# Application Note 374 DS2155 vs. DS21x5y: Software and Hardware Considerations

The DS2155 is a software selectable T1, J1 or E1 Single Chip Transceiver (SCT) for short and long haul applications. This application note intends to highlight many of the differences between the DS2155 and the previous family of Dallas Semiconductor's SCTs. While, the DS2155 is pin compatible with previous Dallas Semiconductor SCT's (DS2152/54, DS21352/552, & DS21552/554) the register set for the device is much more complex. In the following pages, we will identify features from the DS21x5y devices and pinpoint their register locations in the DS2155. Additionally, some of the new features available in the DS2155 will be discussed and what provisions need to be made existing DS21x5y designs or new designs in order to use the DS2155. This note is broken into 4 sections. First, the location of DS21x52 (T1) and DS21x54 (E1) features will be linked to the DS2155 register map. The note will then discuss some of the new features that are available to users in all modes of operation. The last section deals with hardware considerations when using the DS2155.

Figure 1. PINS 36, 54 AND 76 USAGE

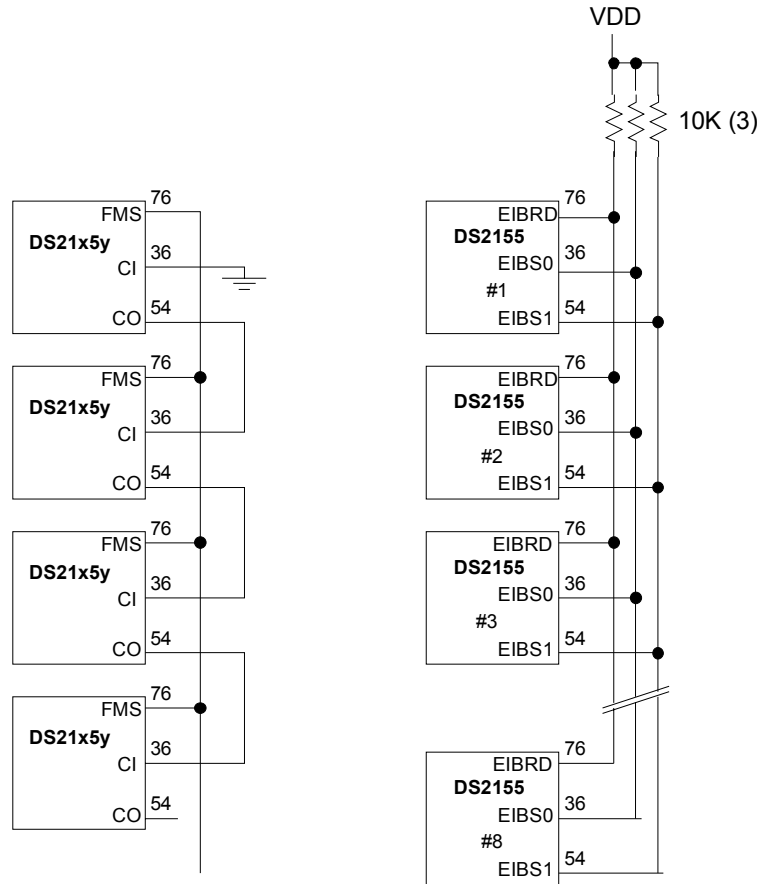
**5.1 REASSIGNED PIN FUNCTIONS FOR PINS 36, 54, AND 76**

The Interleave Bus Option (IBO) has been converted to full software control in the DS2155 and the pins (CO, CI) reassigned to the ESIB function. These pins plus FMS are now used for a new feature (Extended System Information Bus). In this application, up to 4 SCTs can share a single, higher speed PCM bus as shown in Figure 1a. The CO and CI signals were used to establish the master/slave relationship of the devices. In the DS2155 this relationship is software configurable and the CO/CI pin function is deleted. In the DS2155 these pins have been used for another function, the ESIB as shown in Figure 1b. In addition, the FMS pin function has been deleted and replaced with a new signal to support the ESIB.

When provisioning a new DS21x5y design to accept the DS2155 the designer must plan for the reconfiguration of these pins on the PCB in order to use the ESIB feature.

**Figure 3. DS2155 NETWORK INTERFACE**

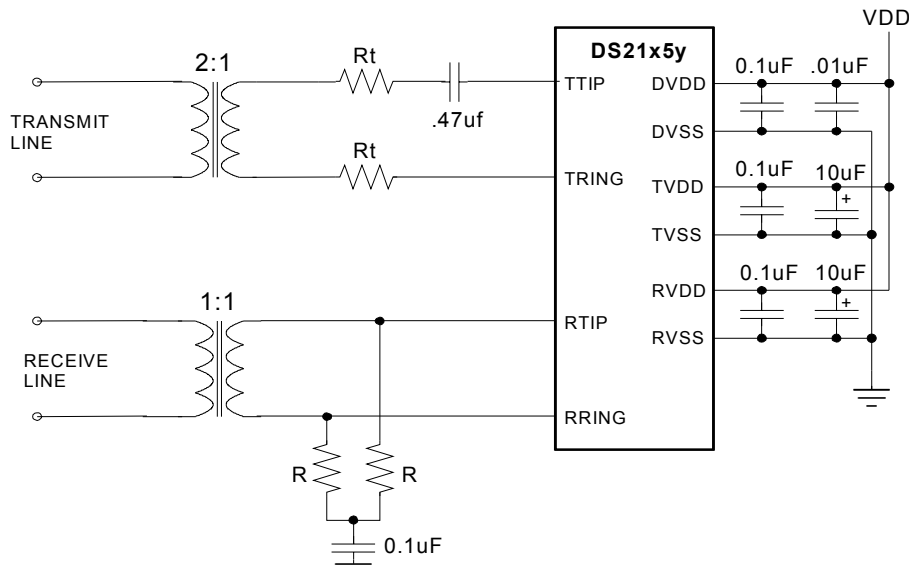
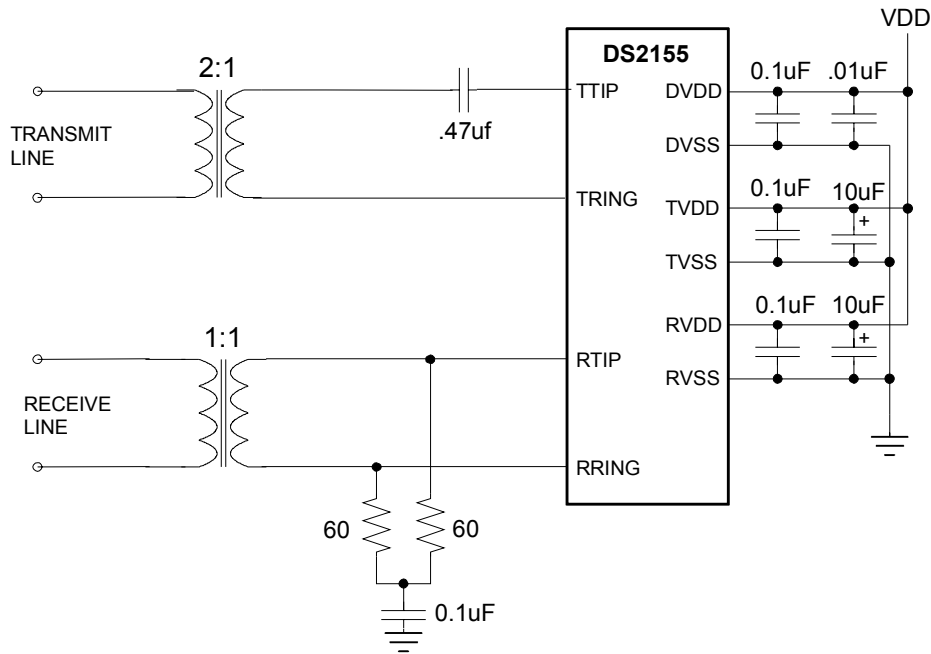
The DS2155 has an enhanced line interface unit (LIU). There are internal, software selectable provisions for terminating the receive and transmit pair. Receive and transmit termination can be altered via software in the DS2155 eliminating the need to change external components. Shown in Figure 2 is the basic interface circuit for the DS2135y (3.3 volt) family.  $R_t$  is set to 0 ohms for T1, and to 11.6 ohms or 6.2 ohms in E1 mode depending on the line type (120 ohm twisted pair or 75 ohm coax) when a high return loss value is required.  $R$  is set to 50 ohms for T1 and 37.5 ohms or 60 ohms for E1 operation depending on the line type.

When the DS2155 is used in an existing DS2135y design, the internal termination features can be disabled if the external circuitry cannot be modified to allow the software controllable termination features to be utilized.

Figure 3 shows the basic circuit for the DS2155. In this circuit R is set to 60 ohms. This value is adjusted internally via software for T1 and E1 operation.  $R_t$  is not needed since the DS2155 transmitter can control source impedance via software for T1 and E1 operation. The user should consult factory application notes for “over voltage” protected interface designs.
